SITE SUPPLEMENTAL INSTRUCTION

PROJECT: Forestside Estates
Attmar & Palleschi Drive
Brampton, ON

SITE SI NO. M-1

PURPOSE: To revise mechanical layout to suit architectural CS drawing and City comments for P1 level.

TITLE
BLOCK 'C'
4TH FLOOR - PLUMBING/SANITARY

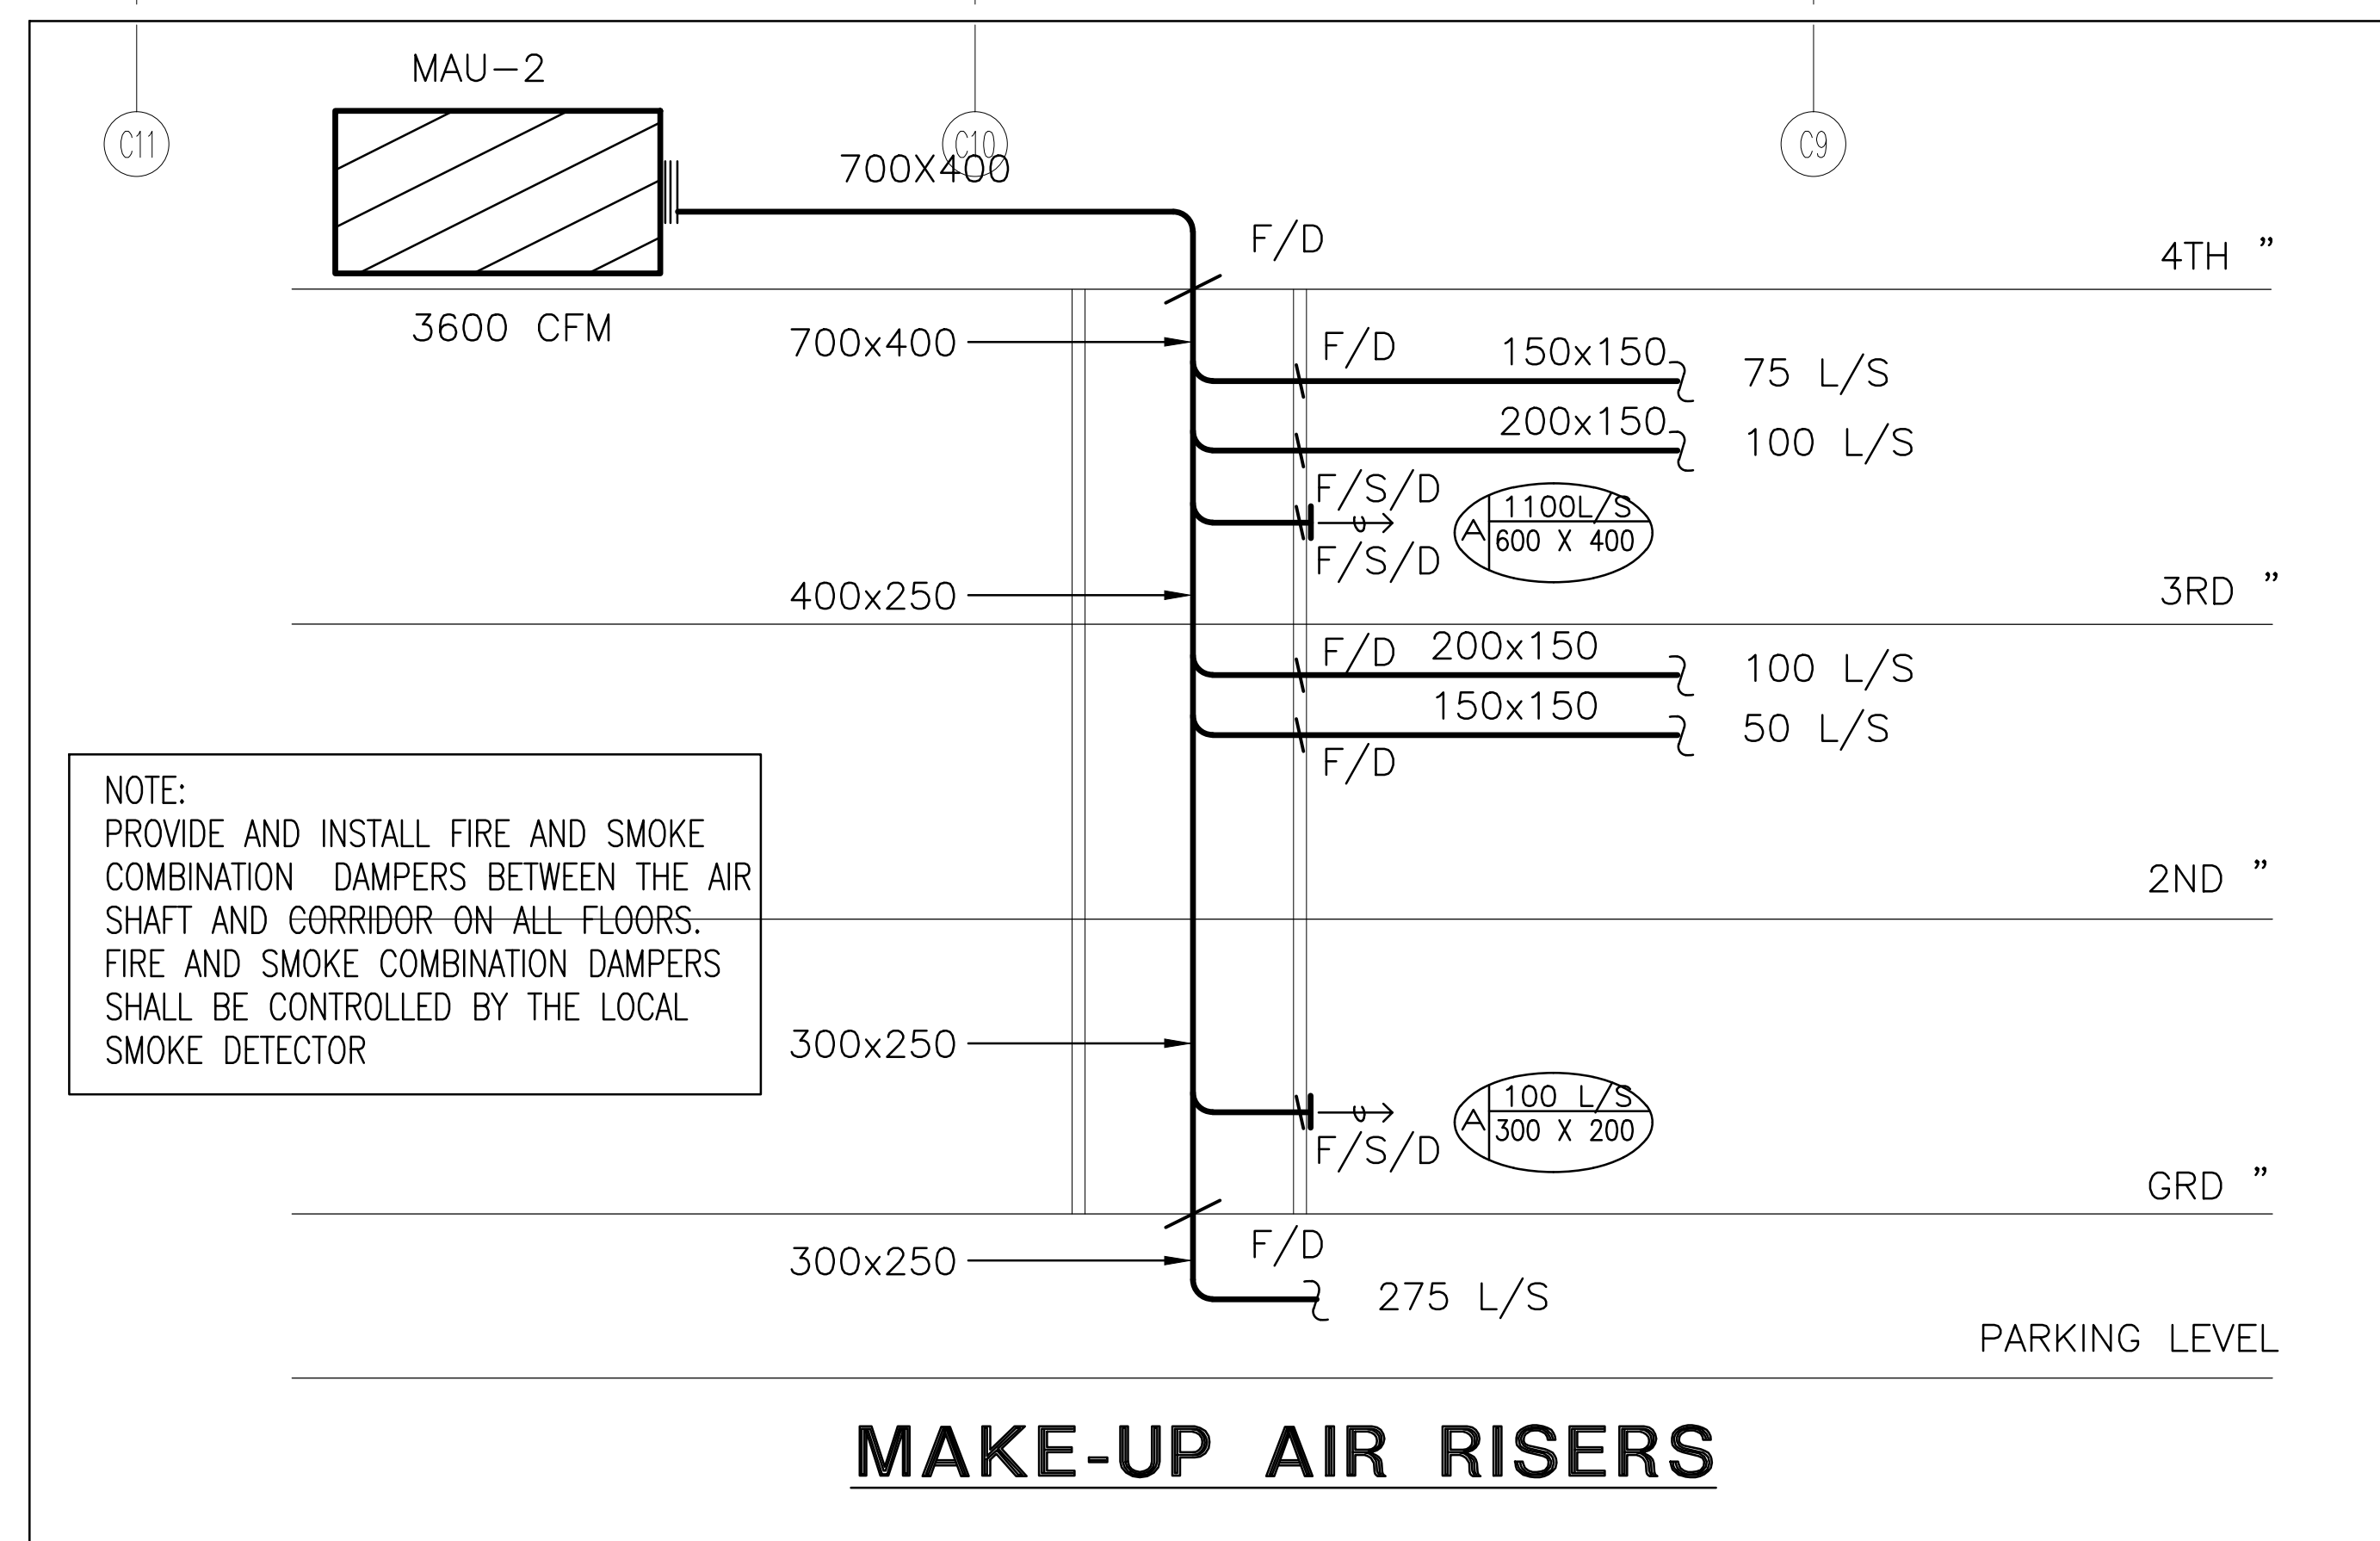
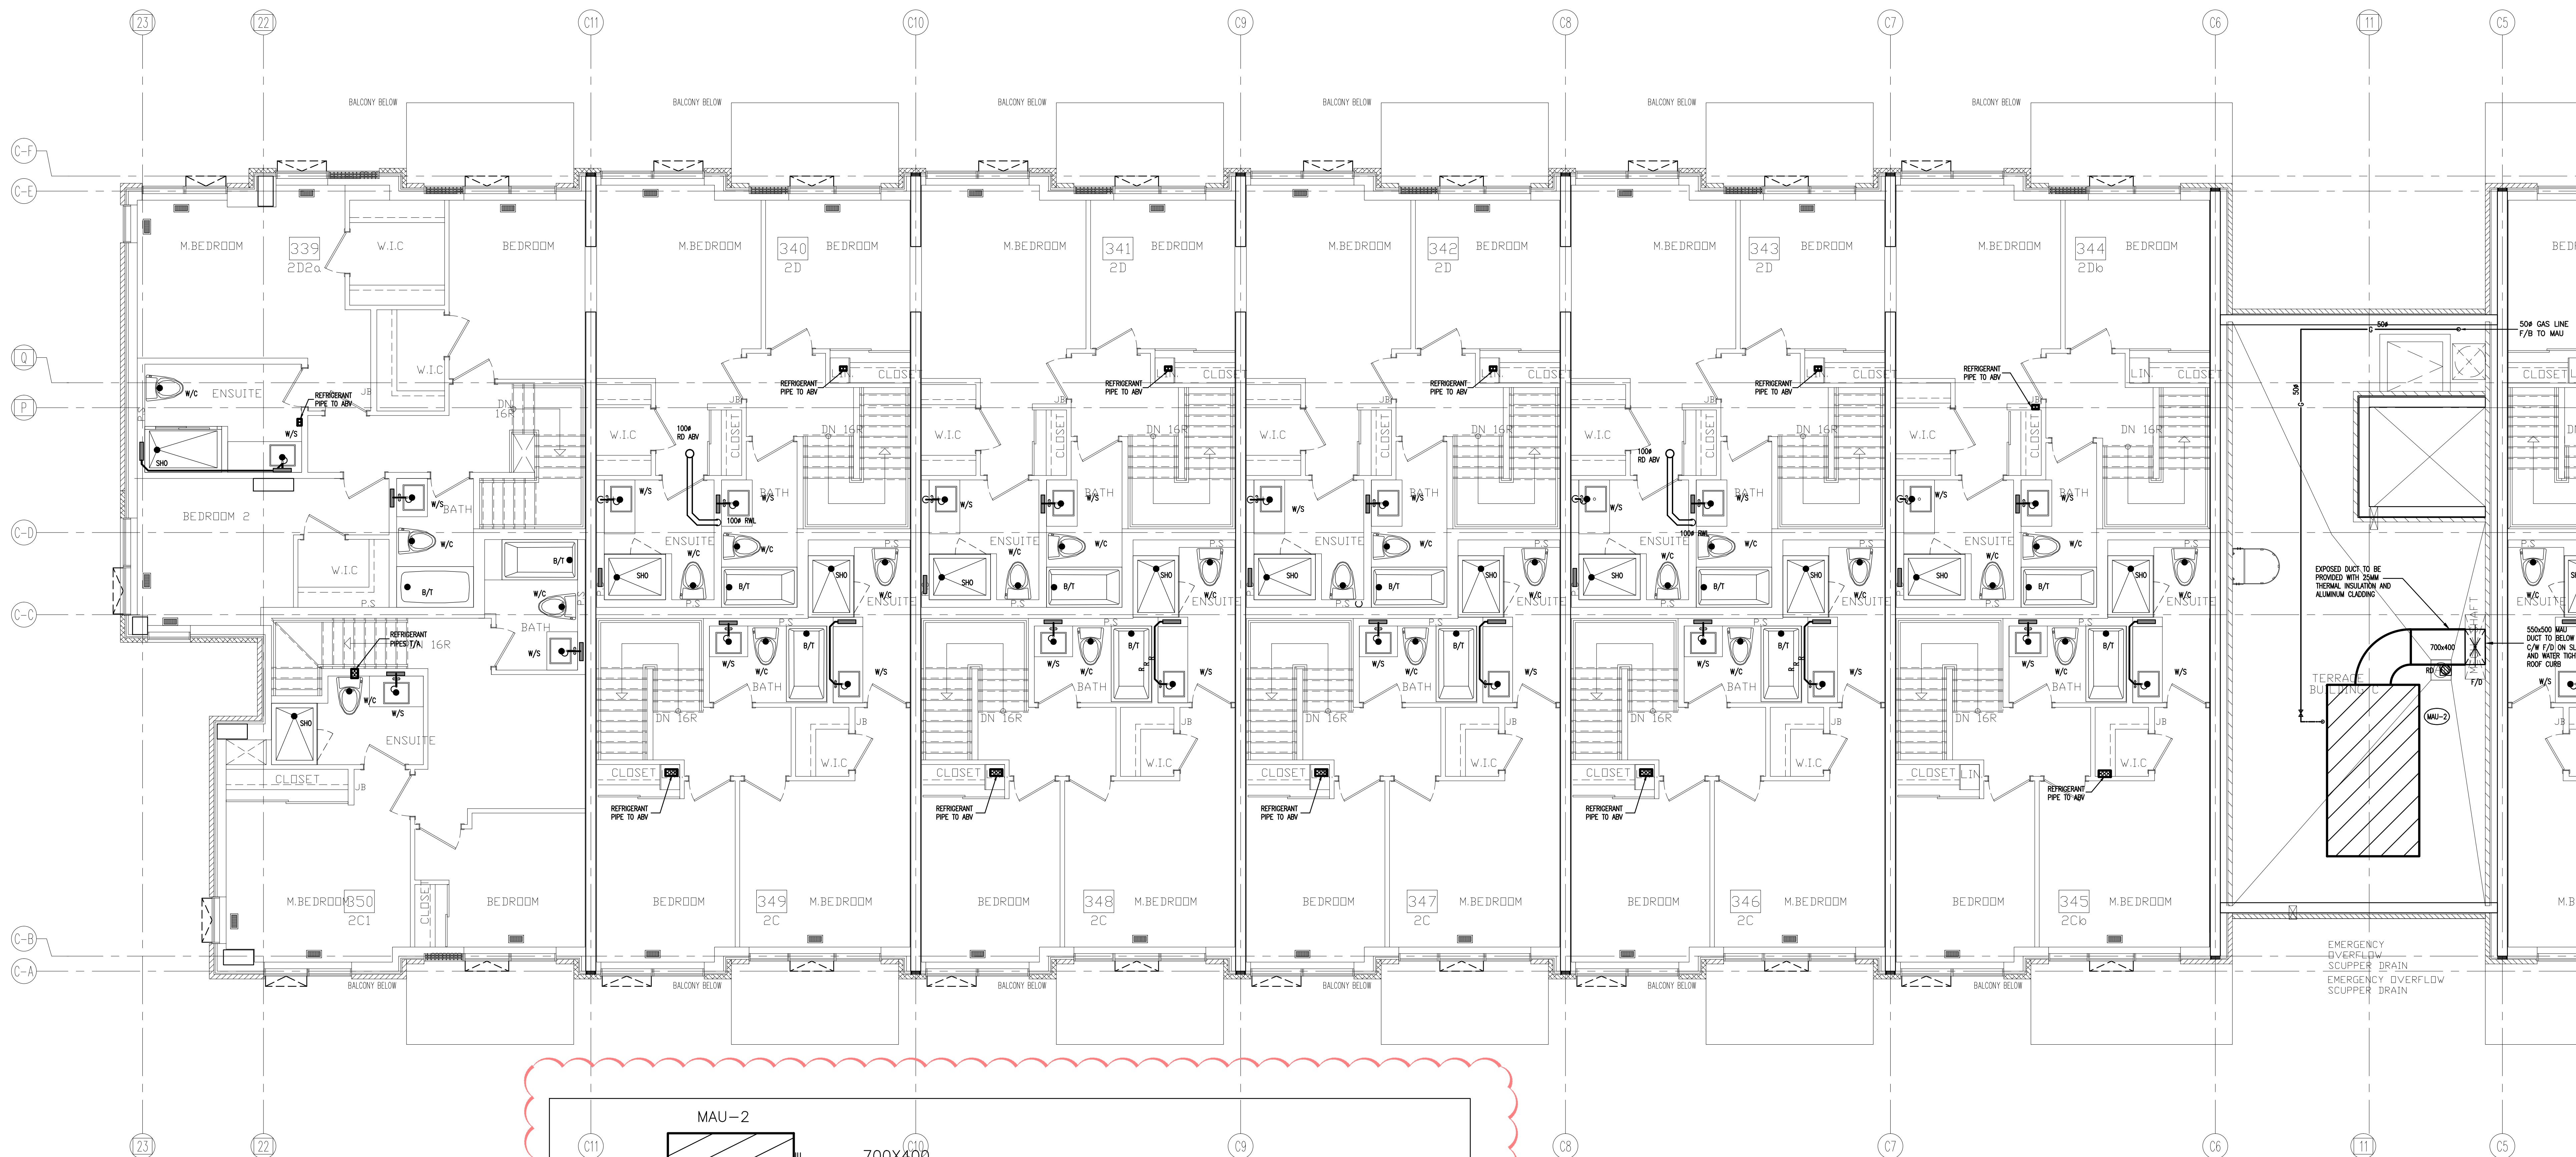
6.0 Reference Drawing M-21 (Blk “C” 4th1 - Mechanical) Issued

6.1 Revise: Mechanical make-up air riser.

6.2 Added: Combined fire and smoke damper for all the opening to public corridor.
